CONGRUENT SOFTWARE, INC.
98 Colorado Avenue
Berkeley, CA 94707
(510) 527-3926
(510) 527-3856 FAX

FROM: Peter Johansson
 TO: T10 SBP-3 working group
 DATE: July 24, 2003
 RE: SBP-3 isochronous data transfer greater than 64 kiB

The changes that follow are suggested for SBP-3 Revision 4a with the intention that a second public review be conducted on a revised draft. Since the SBP-3 working group is no longer meeting face-to-face, this matter will be the subject of a T10 plenary vote in September. SBP-3 working group members and other interested parties should comment via the reflector so that a consensus position (or lack thereof) may be reported to the T10 plenary.

Figure 15 – Command block ORB (single, [non-isochronous](#) buffer descriptor)

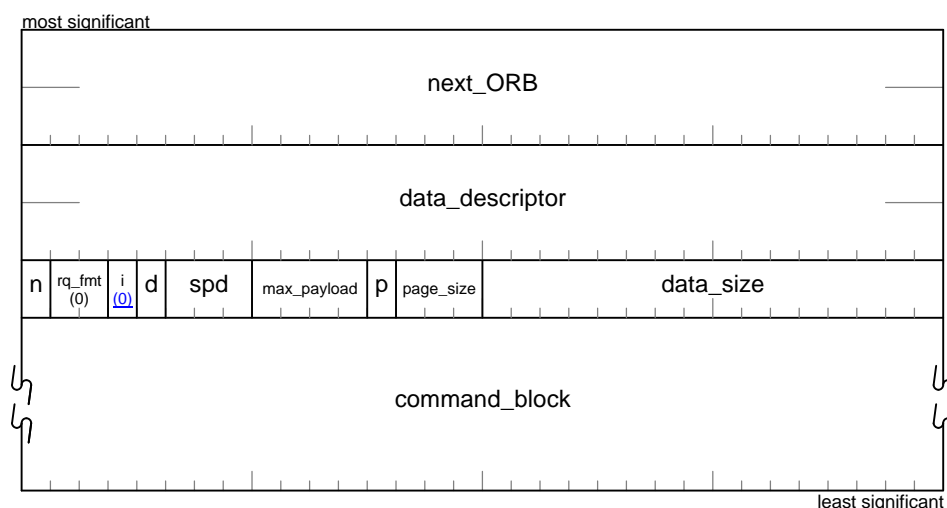
Command block ORBs may have either one or two buffer descriptors [that may specify isochronous or non-isochronous methods for data transfer](#). The format of a command block ORB with a single, [non-isochronous](#) buffer descriptor is illustrated by the figure below.

The ~~value of the~~ *data_descriptor* field is ~~valid~~ [defined](#) only when the *isochronous* bit is zero and [its value is valid only when](#) *data_size* is nonzero, in which case it shall contain either the address of the data buffer or the address of a page table that describes the memory segments that make up the data buffer, dependent upon the value of *page_table_present* bit. The format of the *data_descriptor* field, when it directly addresses a data buffer, shall be a 64-bit Serial Bus address or, when it addresses a page table, shall be as specified by Figure 10. When *data_descriptor* specifies the address of a page table, the format of the page table shall conform to that described in 5.3.

The ~~value of the~~ *spd* field is ~~valid defined~~ only when the *isochronous* bit is zero and ~~its value is valid only when~~ *data_size* is nonzero, in which case it specifies the speed that the target shall use for data transfer transactions addressed to the data buffer or page table, as encoded by Table 1.

The ~~value of the~~ *max_payload* field is ~~valid defined~~ only when the *isochronous* bit is zero and ~~its value is valid only when~~ *data_size* is nonzero, in which case the maximum data transfer length is specified as $2^{max_payload + 2}$ bytes, which is the largest data transfer length that may be requested by the target in a single Serial Bus read or write transaction addressed to the data buffer. The *max_payload* field shall specify a length less than or equal to the maximum asynchronous data payload specified by IEEE 1394 for the data transfer rate indicated by *spd*.

The ~~value of the~~ *page_table_present* bit (abbreviated as *p* in the figure above) is ~~valid defined~~ only when the *isochronous* bit is zero and ~~its value is valid only when~~ *data_size* is nonzero, in which case it shall be zero if *data_descriptor* directly addresses the data buffer, else one when *data_descriptor* addresses a page table.

The ~~value of the~~ *page_size* field is ~~valid defined~~ only when the *isochronous* bit is zero and ~~its value is valid only when~~ *data_size* is nonzero, in which case it shall specify the underlying page size of the data buffer memory (see 9.4 for an explanation of target responsibilities with respect to page boundaries). A *page_size* value of zero indicates that the underlying page size is not specified. Otherwise the page size is $2^{page_size + 8}$ bytes. The page size applies to the data buffer whether or not a page table is present. When a page table is used to describe the data buffer, the *page_size* field also specifies the page table format. A *page_size* value of zero indicates an unrestricted page table (also known as a scatter/gather list) while a nonzero *page_size* indicates a normalized page table.

Figure 15a – Command block ORB (single, isochronous buffer descriptor)

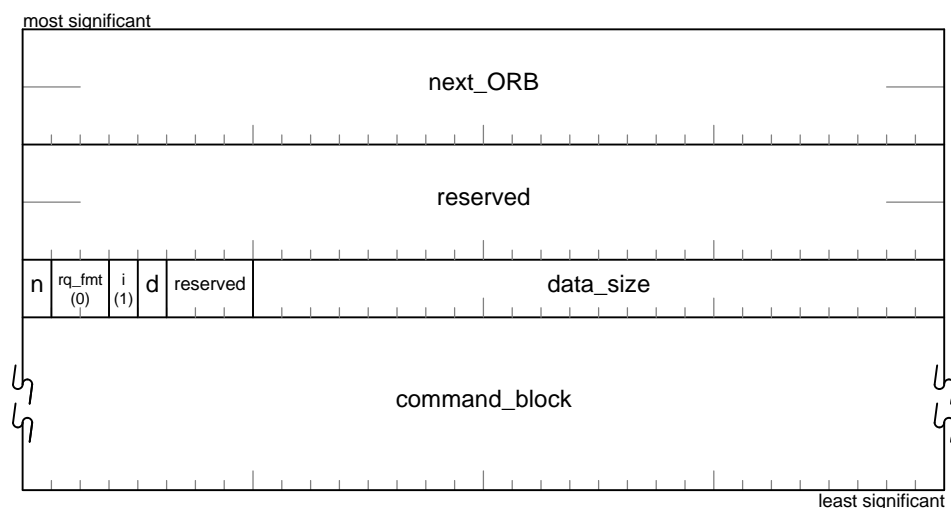
described by the *data_descriptor*, *spd*, *max_payload*, *page_table_present*, *page_size* and *data_size* fields. Otherwise, when *isochronous* is one (see Figure 15a), data transfer shall be effected by Serial Bus isochronous streams, i.e., packets with a transaction code of A_{16} .

As specified above, the *data_descriptor*, *spd*, *max_payload* and *page_size* fields and the *page_table_present* bit are not present in a command block ORB whose *isochronous* bit is one. Some of these fields are reserved; the others are redefined to extend the *data_size* field to 24 bits. The format of a command block ORB with a single, isochronous buffer descriptor is illustrated by the figure below.

Figure 16 – Command block ORB (dual, [non-isochronous](#) buffer descriptors)

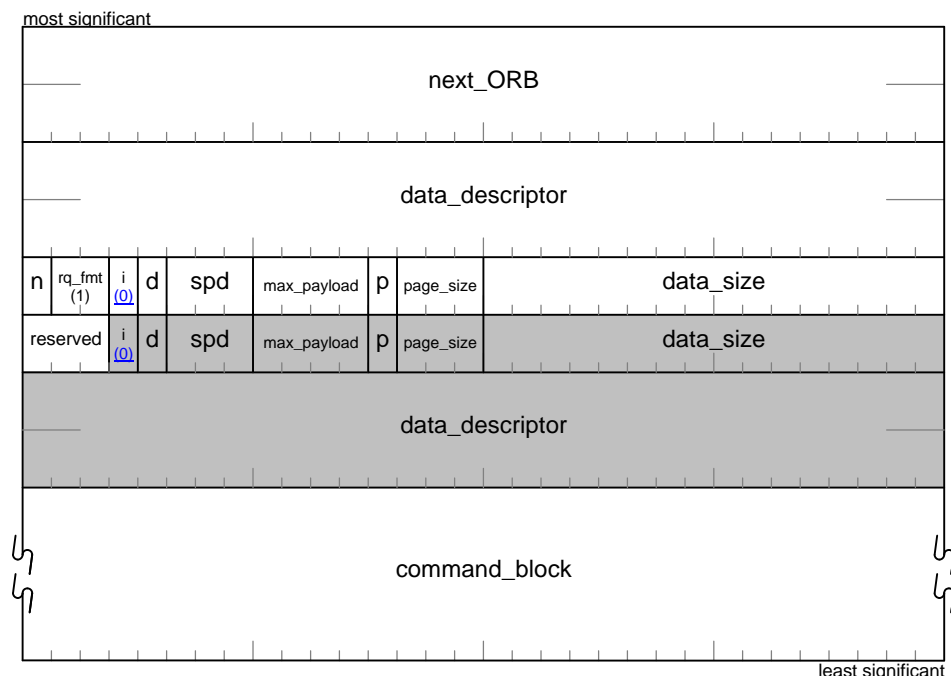
NOTE – Although not illustrated, either or both buffer descriptors may specify isochronous data transfer, in which case the pertinent fields are either reserved or redefined to extend the *data_size* field (see Figure 15a).
